***STATE SIGNIFICANT DEVELOPMENT:  
Section 4.55(1A) Modification Application***

***AUSTRALIAN TECHNOLOGY PARK, EVELEIGH***

***SSD 7317 MOD 5***

Environmental Assessment Report  
Section 4.55(1A) of the *Environmental Planning and  
Assessment Act 1979*

**Figure 2: Section showing the new tunnel below Locomotive Street (in red) and the future connection below the Locomotive Workshop (in blue) (Base source: Applicant's RTS)**

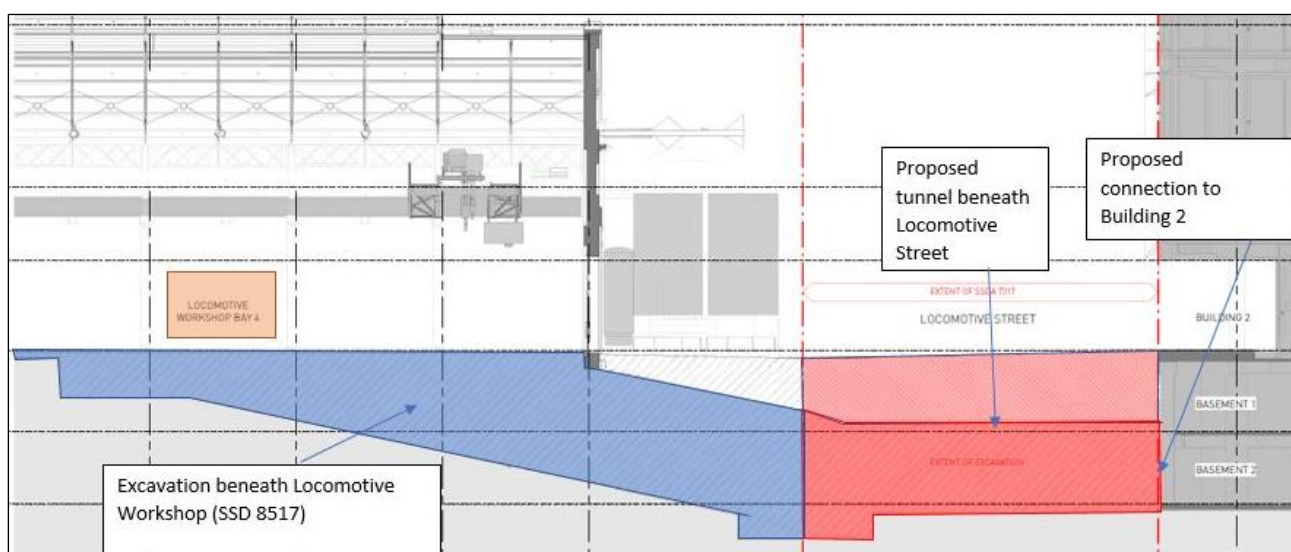
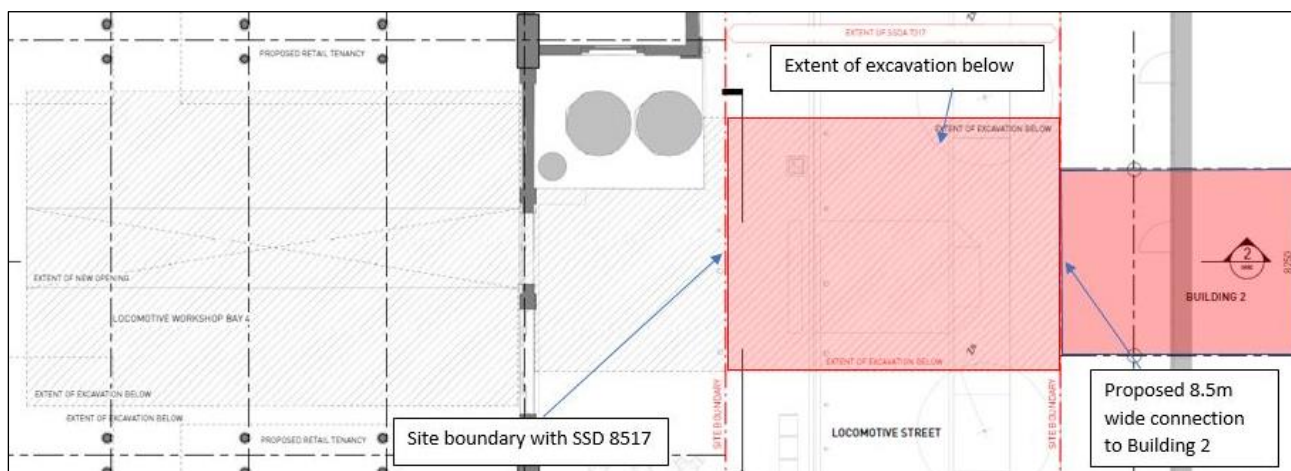
The proposal seeks approval to construct part of a tunnel below Locomotive Street (**Figures 2 and 3**), which is ahead of the determination for the remainder of the tunnel and the traveller (through SSD 8517) that will connect into the Locomotive Workshop.

While Council does not object to the application, it noted that this modification application and the application for the remainder of the tunnel and traveller should be assessed concurrently. The NSW Heritage Council notes that support for this modification should not imply approval for the traveller, which requires a separate application. In this regard, the Department notes the NSW Heritage Council have provided in principle support for the adaptive reuse of the Locomotive Workshop (SSD 8517), but requires further details on the design of the traveller, including details on how it integrates with the Locomotive Workshop.

The Department supports the proposal, as deferring the construction of the tunnel until the remainder of the tunnel works are determined will serve to delay the delivery of the public domain works to Locomotive Street, which may unnecessarily reduce public access through the ATP site. The Department also notes that the tunnel itself, capped at either end by hoardings, will not result in any additional adverse visual, heritage or design impacts, and would be of limited consequence to the locality in the unlikely event that it is not able to be completed. In this regard, the Department supports the NSW Heritage Council recommendation for a condition that no approval is granted or implied for the traveller within the tunnel shell.

The Department therefore supports the application, subject to the recommended condition.
